Responses to the interactive comment on “Measuring dynamic wake characteristics with nacelle mounted LiDAR systems” by Inga Reinwardt et al., manuscript number: wes-2019-89

Responses to the referee: Helge Aagaard Madsen (hama@dtu.dk)

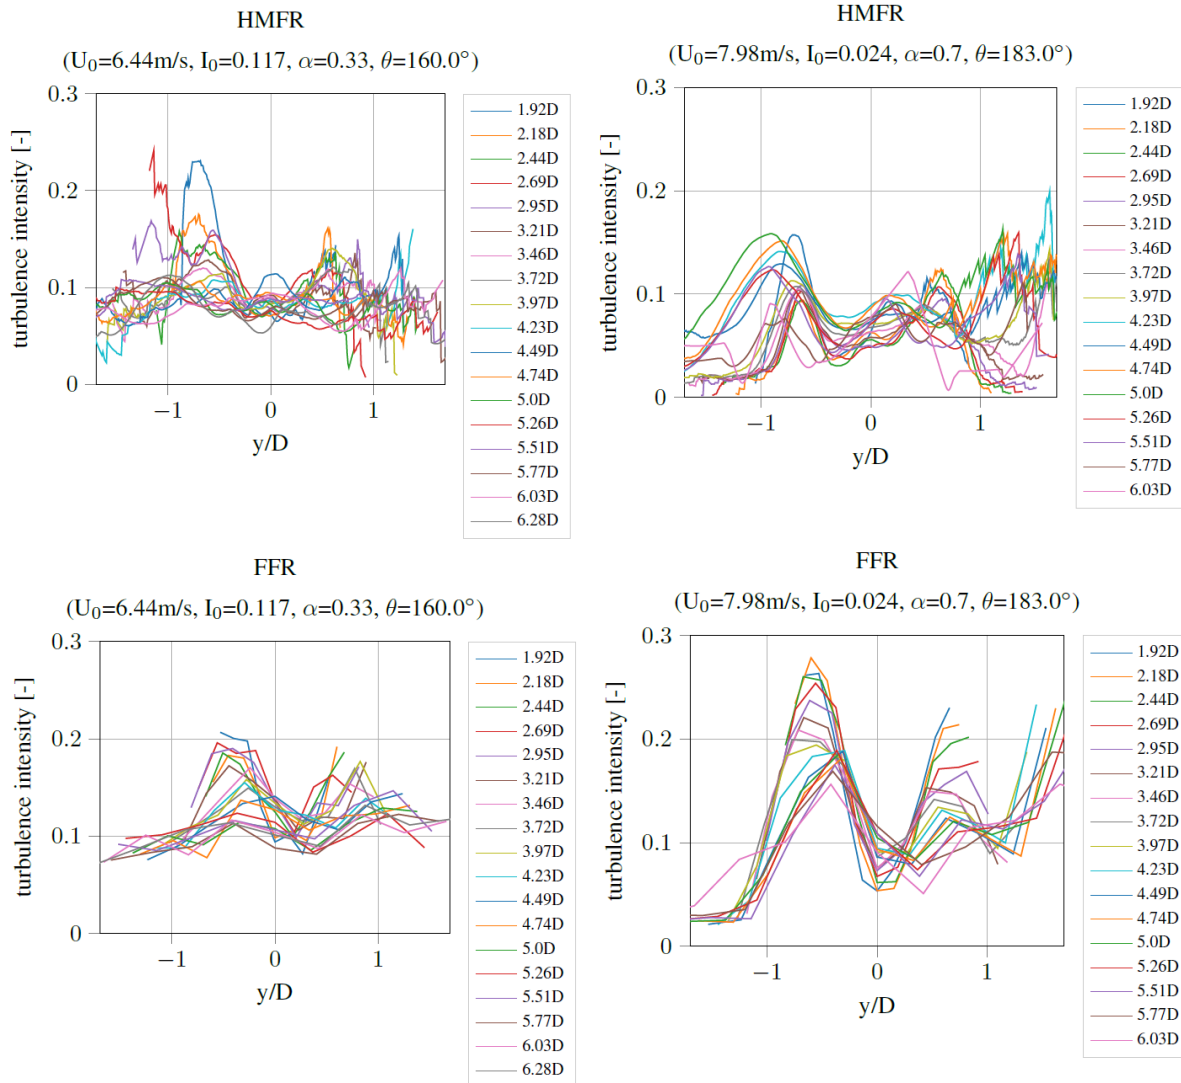
- ... “After averaging, the plausibility of the results is inspected. If the calculated minimum mean wind speed in the MFR is higher than the minimum mean wind speed in the FFR, it is assumed that the Gauss fit failed and the results are no longer considered.”
 - Besides this plausibility check I would propose to show the standard deviation of all the measurement points around the average MFR from the individual scans, just for a few cases. This will give information about how much averaging is behind the final MFR deficits.

Response: The plots for the corresponding turbulence intensities for Figure 6 (HMFR) and 7 (FFR) are given below. The comparison of the turbulence intensity in the HMFR and FFR show a decrease of the two maxima at the turbulence intensity in the HMFR, which is expected due to the transformation to the HMFR. The two maxima do not vanish completely in the HMFR graphs due to the small-scale turbulence, which is related to blade tip and root vortices as well as the wake shear itself. Additionally, the turbulence which is related to the vertical meandering is still included. Furthermore, the ambient turbulence intensity of

11.7% and 2.4% can be seen towards the edges of the curve, where the wake influence decreases.

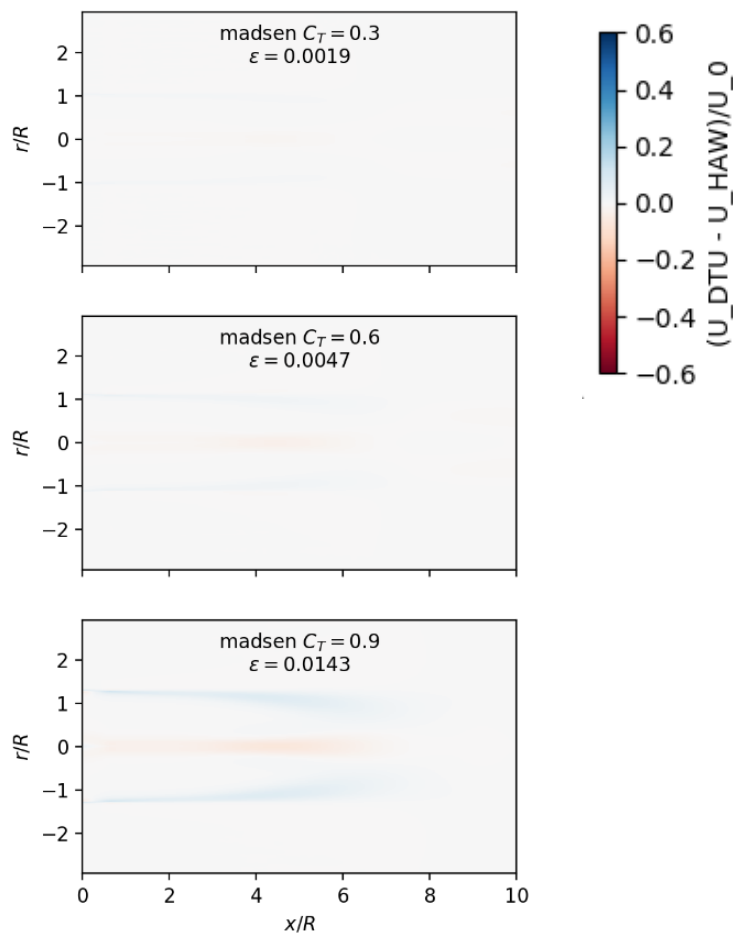
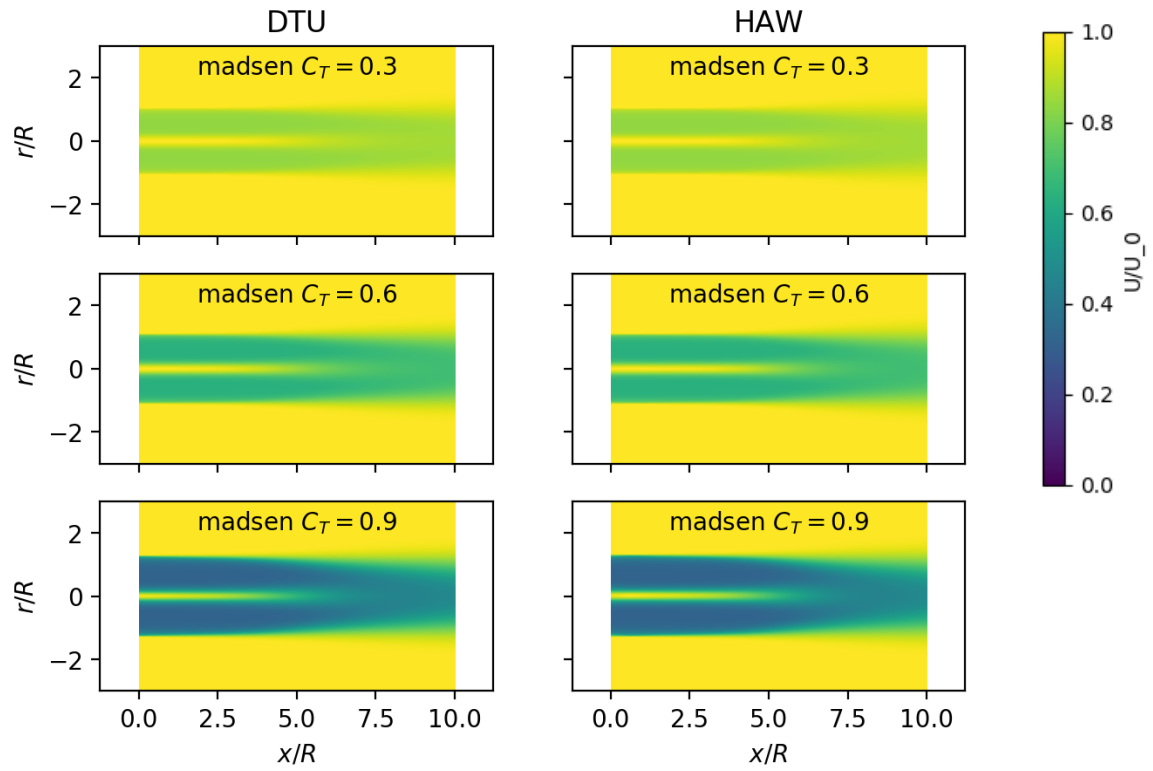
- As concerns the results in Figure 10 and Figure 11 for the DWM-Egmond model they seem not to agree with simulations with our DTU implementation of the DWM model, however with the uncertainty of just assuming a similar turbine operation but without knowing the details of the turbine

- The authors are encouraged to share and upload more details of their simulations so that the results can be checked with an original implementation of the so-called DWM-Egmond model.

- Further, it is proposed to show a figure with e.g. the mean velocity of the wake deficit or the mean velocity cubed (to show reduction in power of the downstream turbine) and otherwise in the same way as Figure 9. The mean velocity is a more robust characterization of the wake deficit than the minimum value velocity within the deficit. The minimum value can easily be influenced by the details of the aerodynamic modelling of the turbine.

Response: A comparison between the static deficit, respectively the solution of the thin-shear layer equations with an implementation of the DTU has already been carried out. The model has been compared to the Python implementation of Jaime Yikon Liew. The two implementations match very well (see following figures). The figures show results from the so-called DWM-Egmond model of both model implementations and their difference (ϵ is the mean difference).
